Re: CCR Surface Impoundment Design Criteria  
Huntley Generating Station  
Tonawanda, New York

Re: Pond Embankment Evaluation  
Huntley Generation Plant  
Tonawanda, New York

**NRG OCTOBER 2014 RESPONSE TO EPA REPORT  
NRG HUNTLEY PLANT  
TONAWANDA, NEW YORK**

PROJ MGR: DJT	REVIEWED BY: BAK	CHECKED BY: DJT	FIGURE <b>9</b>
DESIGNED BY:	DRAWN BY: DEW	SCALE: AS SHOWN	
DATE OCTOBER 2014	PROJECT NO. 21.0056705.00	REVISION NO.	9 OF 10

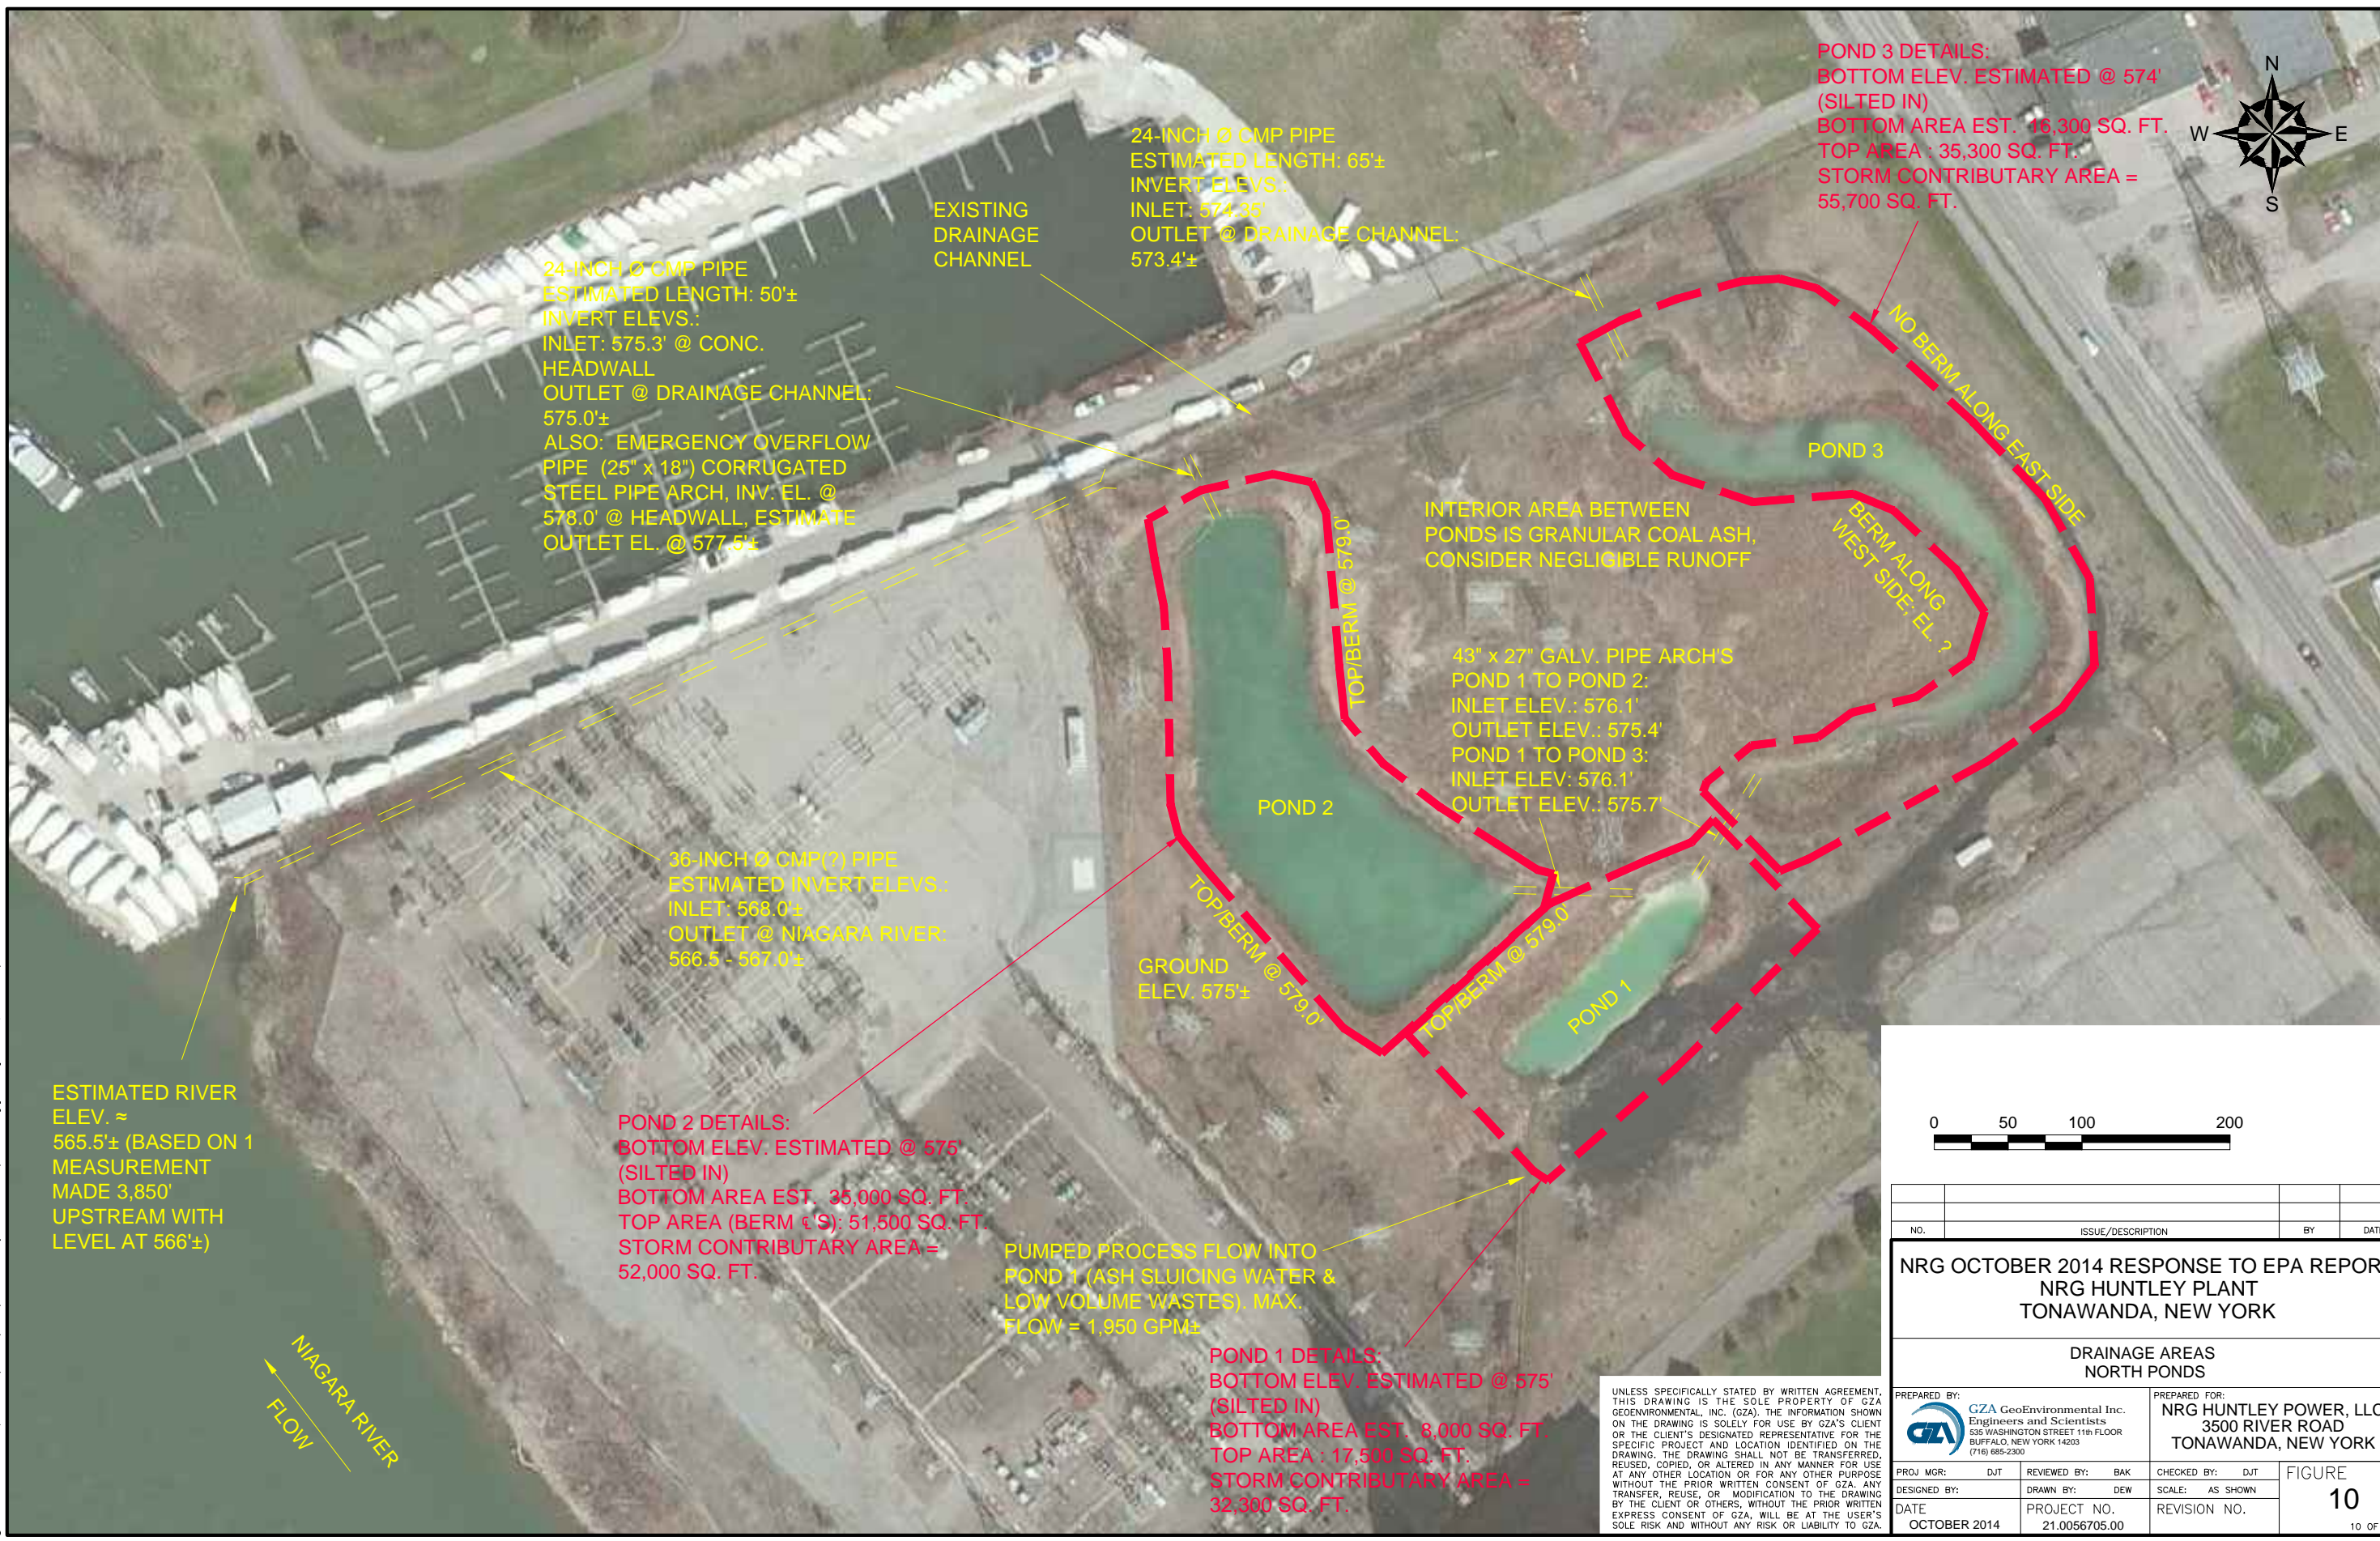
*AMEC comment: “The Equalization Basins drainage area is equal to its total pond footprint of 132,400 (sq. ft.), which matches up with the aerial photo, and indicates that no rainfall runoff from adjacent areas will surface drain into it. The drainage area of the South Ash Settling Pond is 343,700 (sq. ft.), which is larger than the pond footprint and indicates some adjacent area flowing to the pond. Page 6 of the report states that some roadway and building areas flow to this pond. The drainage area for this pond should be delineated on a map for review.*

*table (Table 8, Page 12). The freeboard values from the conclusion are less than 2 feet for Ponds 2 and 3. No model or detailed output was submitted to verify the results presented in the report and to determine which freeboard values are correct”.*

*AMEC comment pertaining to Freeboard Guidelines for the south-side Equalization Basins: “The Equalization Basins have zero or less freeboard throughout many operating scenarios, even with the suggested plan to lower the overflow outlet pipe.”*

GZA Response: GZA has delineated the pond drainage areas as shown on attached Figures 9 and 10.

Section 4.2 of the March 2013 AMEC letter acknowledges that the North and South Equalization Basins were determined to not be CCW impoundments (and were therefore not rated by AMEC). As such, we believe that these equalization basins should not be subject to the freeboard guidelines as stated in Chapter 8, Section 9 of the MSHA Coal Mine Impoundment Inspection and Plan Review Handbook. However, if these equalization basins are required to comply with the stated freeboard guidelines, an additional freeboard (minimum 3 feet high) may be attained atop designated lengths of the existing perimeter berms of the Equalization Basins, as shown on attached Figure 9. Adding freeboard atop

these berm intervals would prevent overflow to the Niagara River and direct the flow to the South Settling Pond. A cross-section view of this potential addition is shown on attached Figure 9.

It is our opinion that since the Equalization Basins are not considered to be CCW impoundments, their minimum freeboard height should not be governed by the above-stated MSHA guidelines. However, if determined economically feasible by NRG, NRG may consider constructing additional berm height to the designated sections of the perimeter berms as shown and detailed on attached Figure 9, to attain a minimum freeboard height of 3 feet.
